**Errata and Response to Public Comments
Anthony C. Beilenson Visitor Center at King Gillette Ranch
Environmental Assessment**

**Santa Monica Mountains National Recreation Area
March 2010**

The following errata and response to public comments together with the Finding of No Significant Impact (FONSI) and the EA describe the final decision of the National Park Service for the Anthony C. Beilenson Visitor Center at King Gillette Ranch.

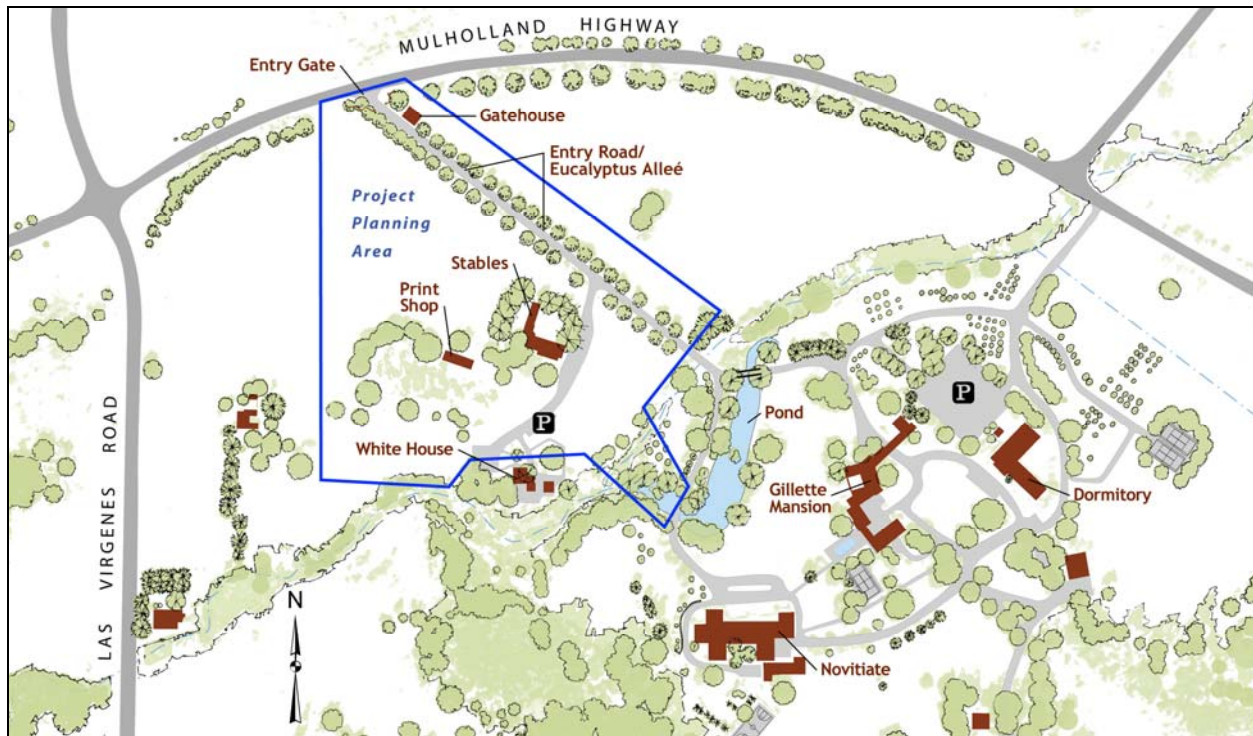
- A. Section 2.1, Alternative A: No Action, Figure 5, Pg. 19. Figure 5 does not illustrate the correct project planning area boundary. Replace Figure 5 with the following map.
